BUILDING 21

THE JOHNS HOPKINS UNIVERSITY APPLIED PHYSICS LABORATORY
LOCATED SOUTHEAST OF INTERSECTION OF ROUTE 29 & 32
HOWARD COUNTY, MD

THE JOHNS HOPKINS UNIVERSITY
APPLIED PHYSICS LABORATORY
COVER SHEET &
VICINITY MAP
TAX MAP 41 PARCEL 123
ELECTION DISTRIC NO. 5
HOWARD COUNTY, MARYLAND

SDP-05-133

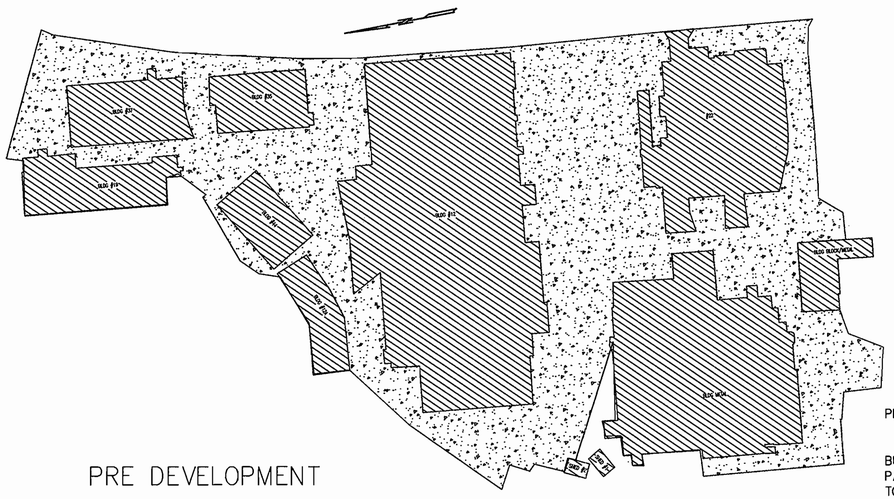
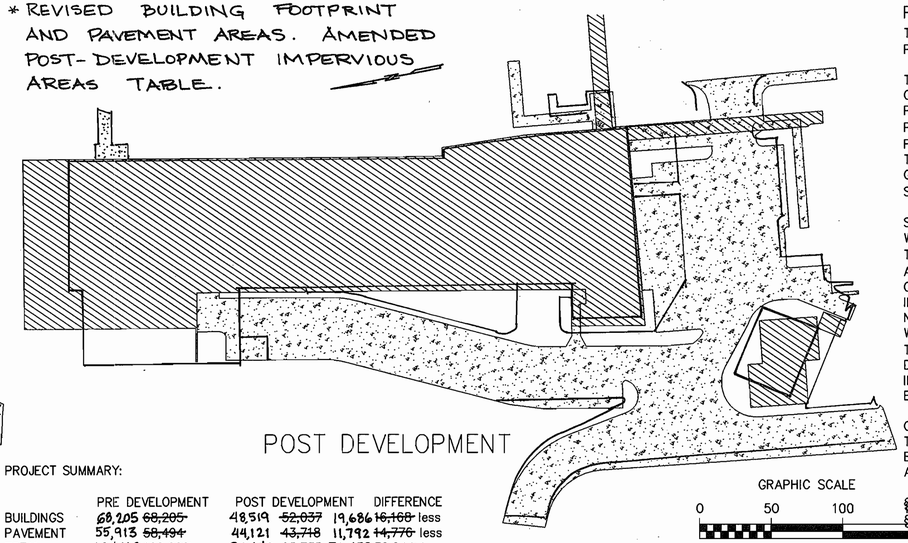
* REVISED BUILDING FOOTPRINT AND PAVEMENT AREAS. AMENDED POST-DEVELOPMENT IMPERVIOUS AREAS TABLE.

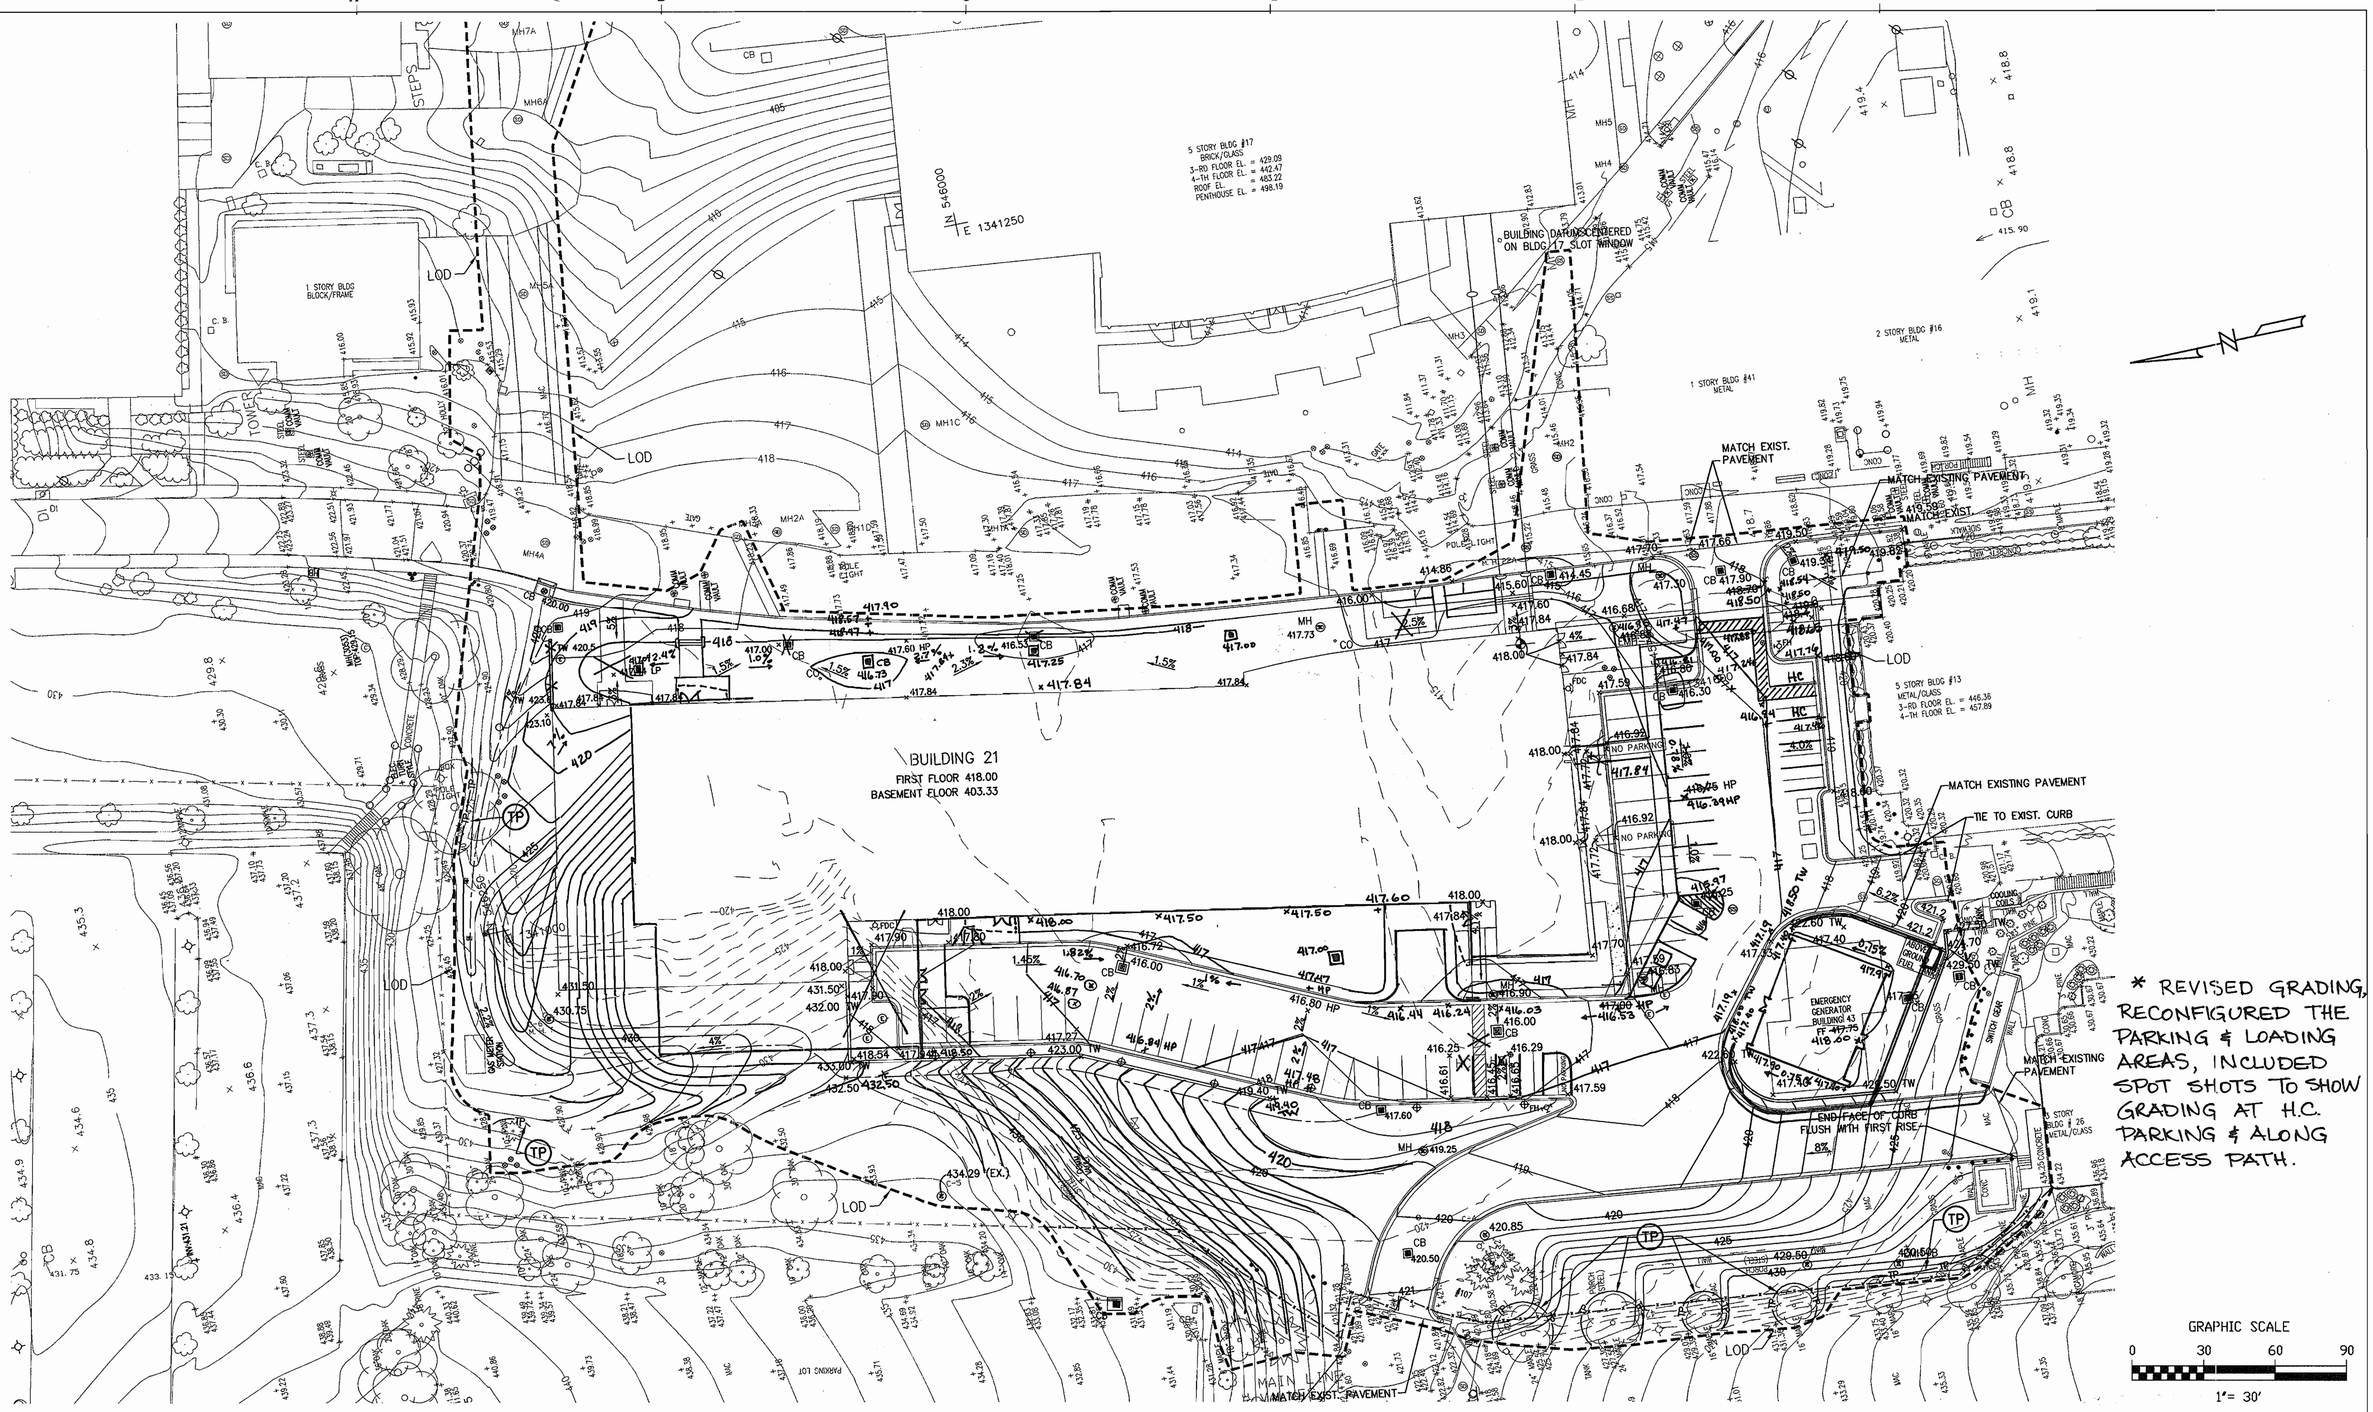
* REVISED GRADING, RECONFIGURED THE PARKING & LOADING AREAS, INCLUDED SPOT SHOTS TO SHOW GRADING AT H.C. PARKING & ALONG ACCESS PATH.
